**ATTACHMENT 1 : MODIFICATIONS HAVE BEEN HIGHLIGHTED.**

**CAMPUS DISTRICT SUBJECT LAND**

**ATTACHMENT 6****MODIFICATION OF JOONDALUP CITY CENTRE STRUCTURE PLAN (CAMPUS DISTRICT)  
SCHEDULE OF SUBMISSIONS FOLLOWING ADVERTISING  
(CLOSED 21 MARCH 2002)**

**4.3 Building Height**

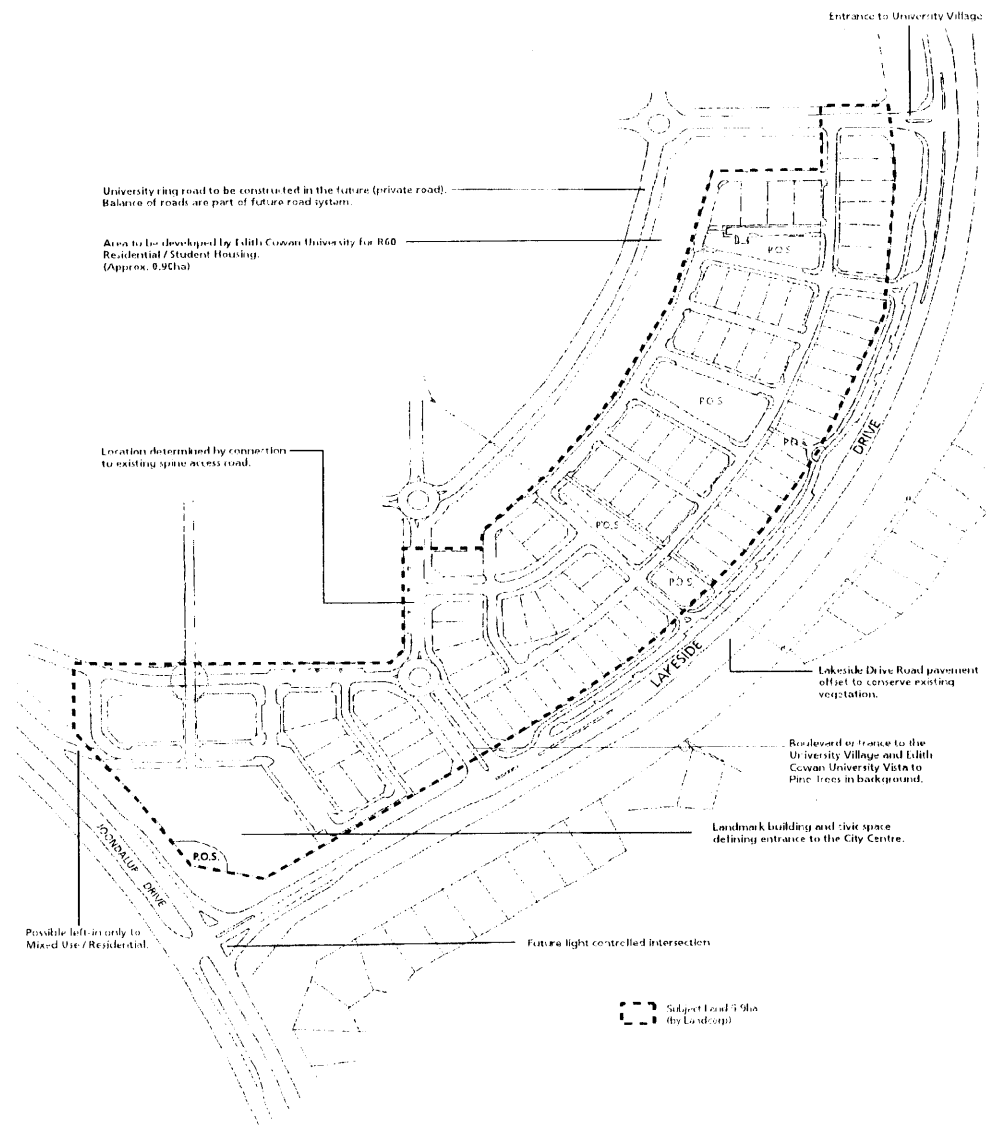
Residential/Mixed Use and Institutional Uses – maximum ~~two~~three storeys. Council may approve a building in excess of two storeys for buildings of considerable landmark quality.

*University Village Indicative Subdivision Guide Plan – Amended*

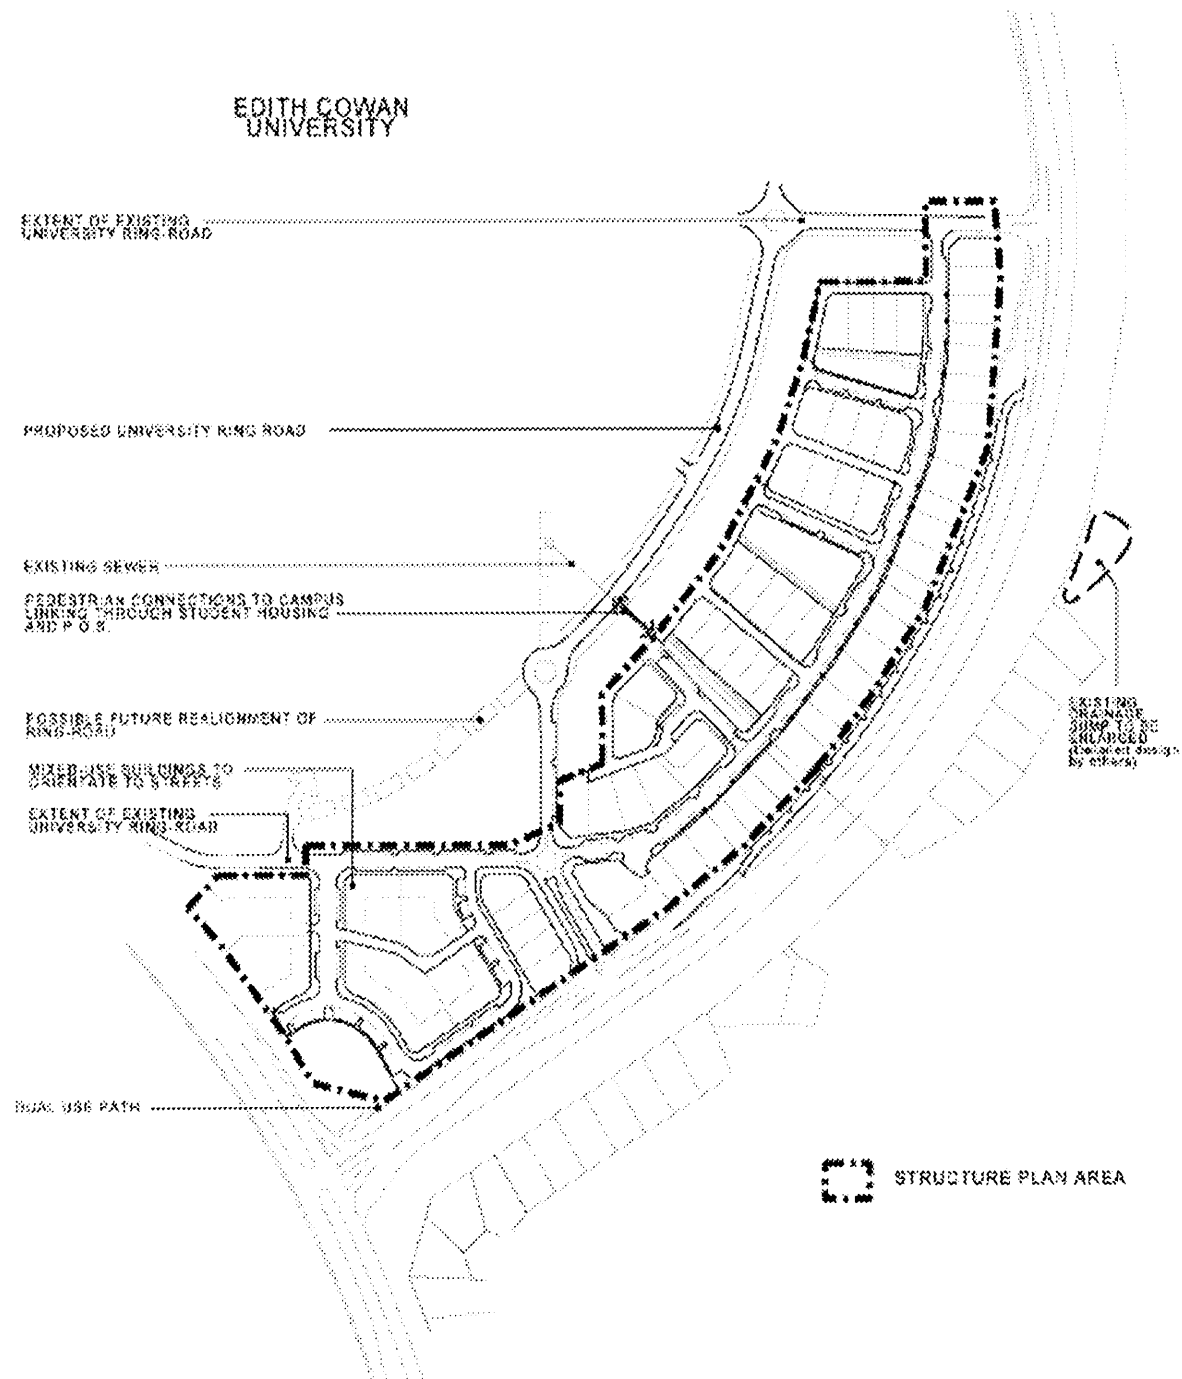
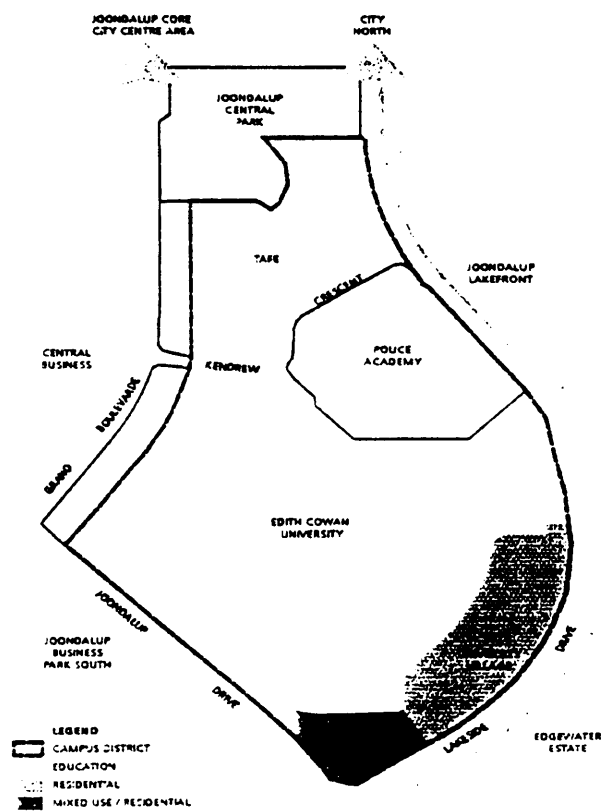
# **ATTACHMENT 2** **Page : 1** **University Village Indicative Subdivision Guide Plan – Existing**

**ATTACHMENT 5**  
***Campus District Land Use Plan – Amended***

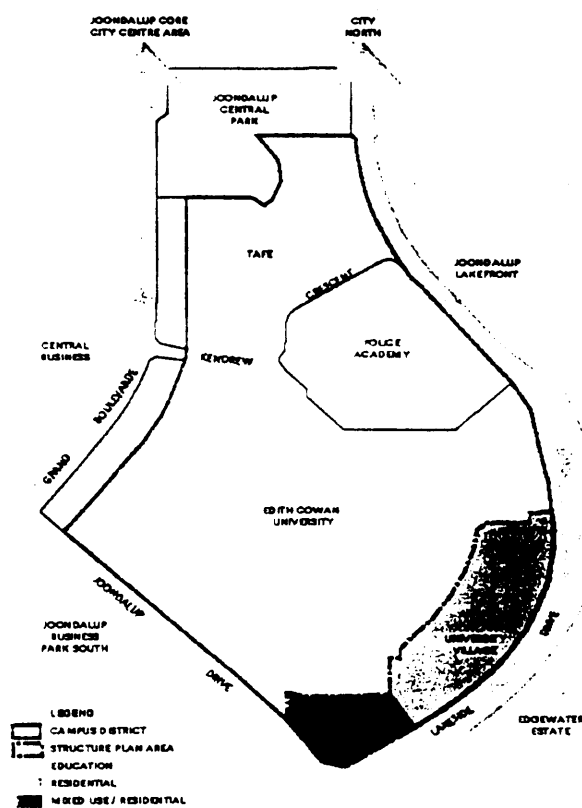
**ATTACHMENT 4**  
*Campus District Land Use Plan – Existing*
